147.2 Service primitives and interfaces

147.3 Physical Coding Sublayer (PCS) functions

Figure 147-3—PCS reference diagram

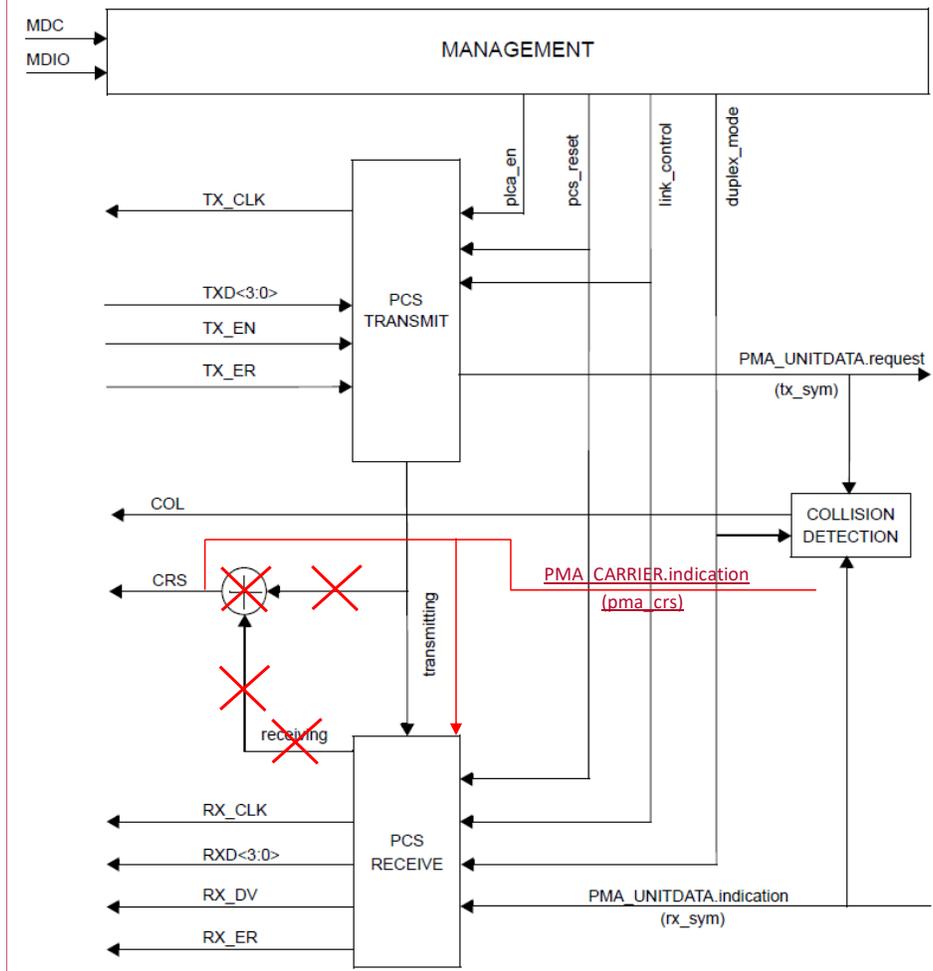
Commented [PB3]: #649: CRS usage
 Modify figure to indicate that CRS is generated out of energy detection in the PMA

Figure 147-4—PCS Transmit state diagram (1 of 2)

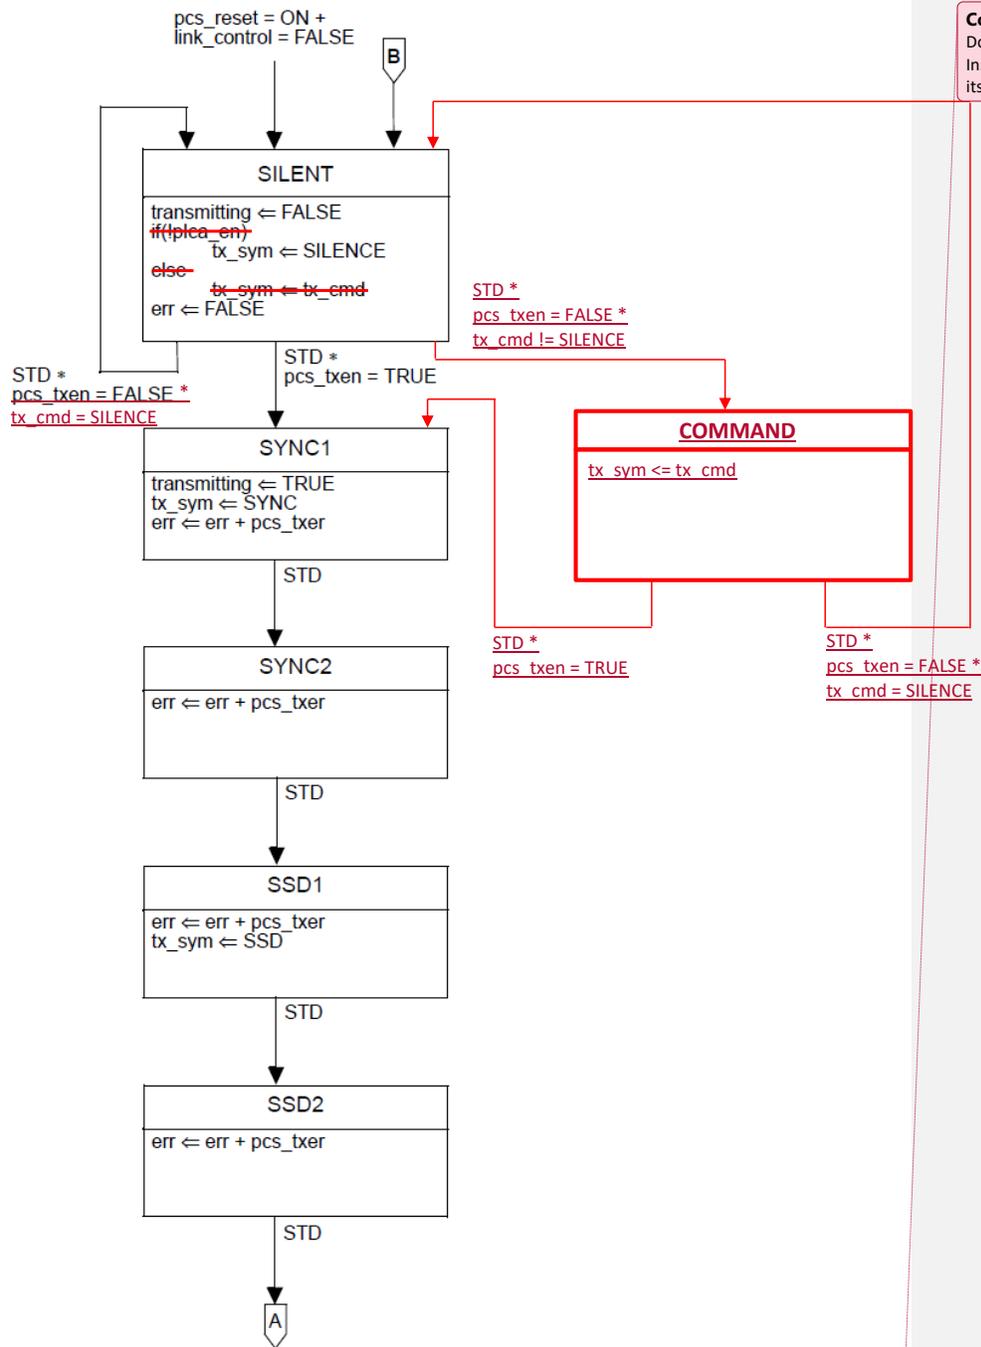
Commented [PB5]: #283: plca_en
 Don't use plca_en in C147 as requested by the comment.
 Instead, rely on tx_sym to be set appropriately, letting RS do its job.
